Chiquita Canyon, LLC
Reaction Committee & South Coast Air Quality Management District
Monthly Meeting
Wednesday, June 18, 2025 at 10:00 am PT

MEETING MINUTES

Thirty Day Maximum Vertical Temperature Map from Temperature Probes at Chiquita Landfill

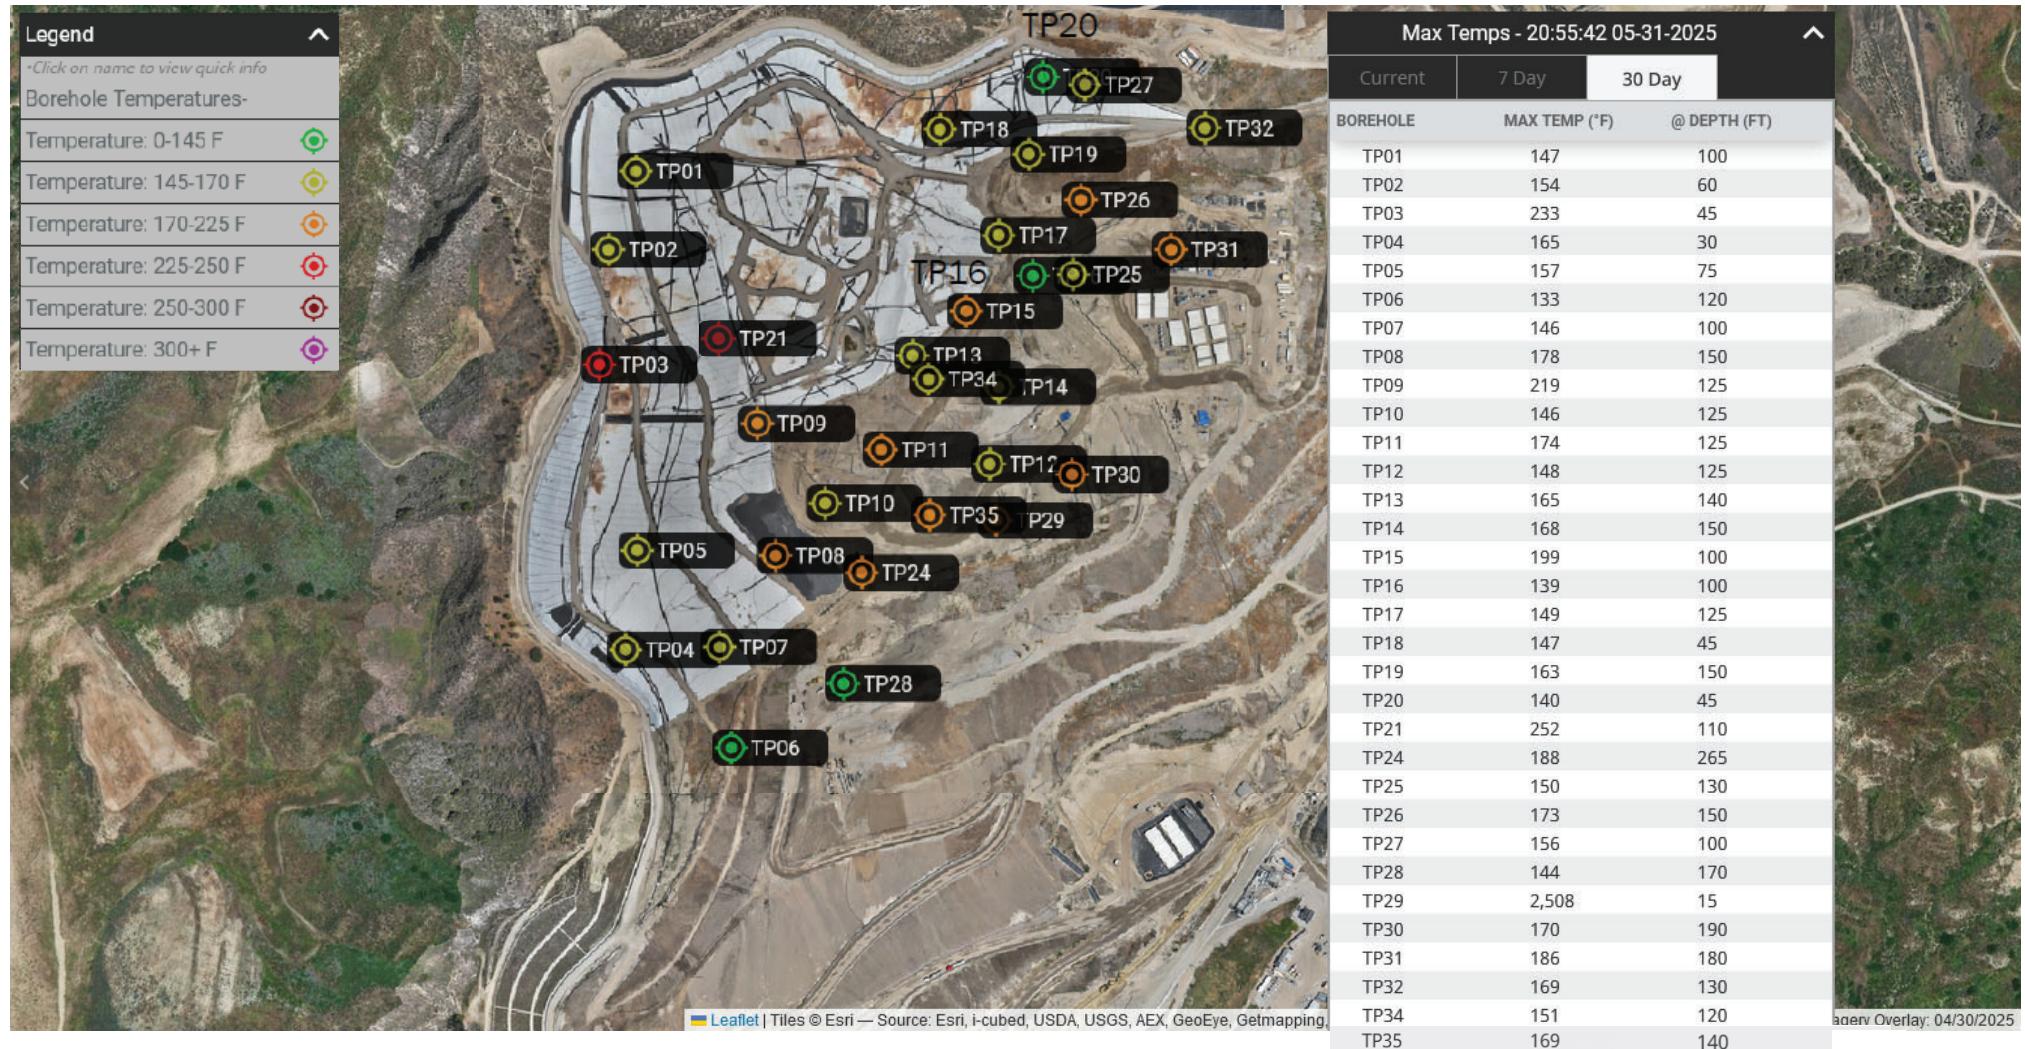
- i. **Outstanding Request:** Ms. Roberts requested that the range map affiliated with maximum in-situ waste temperature probe measurements that were recorded during the relevant time period be provided.
 - 1. **Written Response:** The requested range map is attached to this summary.

As indicated in previous weekly submittals, readings of 2,508°F (shown for TP-29) are not actual temperature readings and are instead the default maximum possible temperature reading that indicate a thermocouple has been unplugged for maintenance, replacement, or other issues. When a thermocouple is unplugged, it reads the maximum possible value of 2,508°F.
